SUBJECT: TRAFFIC METHODOLOGY APPROVAL LETTER

PROJECT NAME: ENCLAVE HOUSING CR 42 TRAFFIC IMPACT STUDY PROJECT #2025010062 APPLICATION: #32409 PARCEL #47667-004-00

RE: Enclave Housing CR 42 Response to Comments

This memorandum has been prepared to provide responses to the comments from Marion County on April 23, 2025. The revised TIA methodology memorandum is provided under separate cover.

Figure 2. Project Trip Distribution

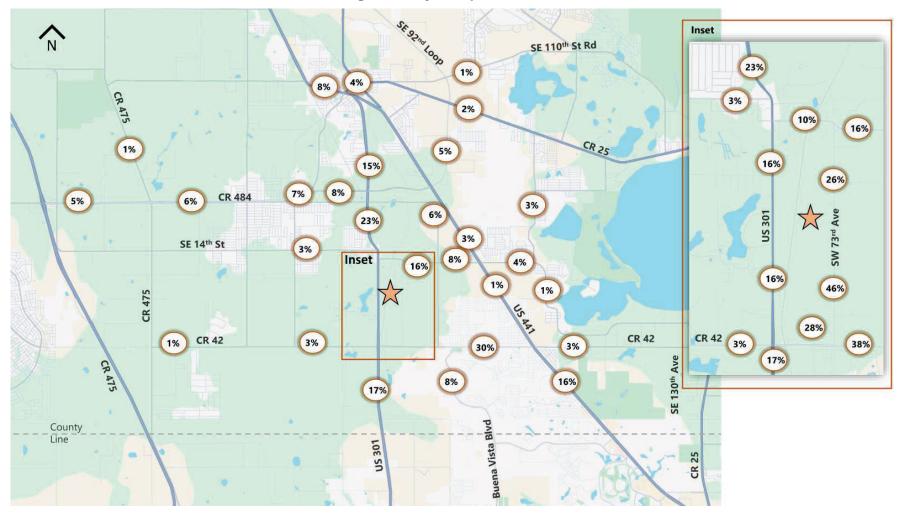
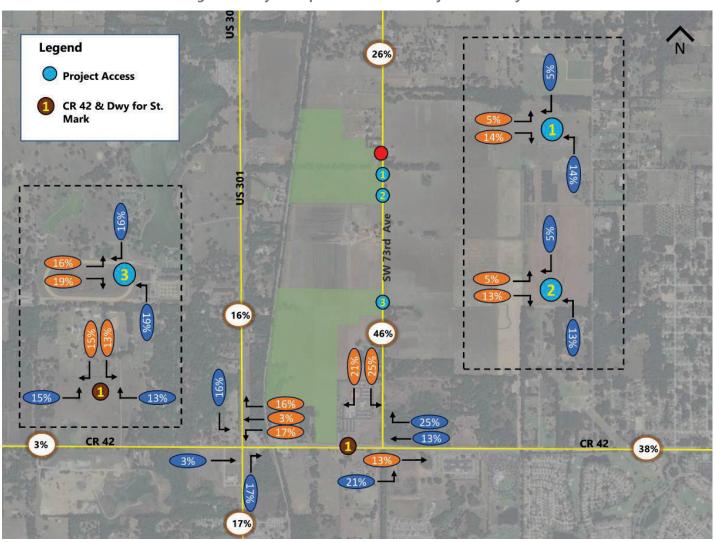
2. PDF pg. 4 & 5, Figures 2 & 3 - Figures 2 & 3 show different distributions to/from the south on SE 73rd Ave. Figure 2 shows 54% while Figure 3 shows 39%. Update the figures to show the same distributions on SE 73rd Ave. Ensure the distributions used in Table 2 also match the distributions shown on Figures 2 & 3.

Response: Agreed, and Figures 2 & 3 are updated accordingly.

4. PDF pg. 5, Figure 3 - The 39% to/from the south on SE 73rd Ave needs to be changed to 46% based on the distributions shown at the driveways on SE 73rd Ave

5. PDF pg. 5, Figure 3 - The 15% of eastbound through traffic on CR 42 at SE 73rd Ave needs to be changed to 13%.

Response: Figure 3 has been updated to show 46% to/from the south on SE 73rd Ave.

Response: Figure 3 has been updated to show 13% eastbound through traffic on CR 42 at SE 73rd Avenue.
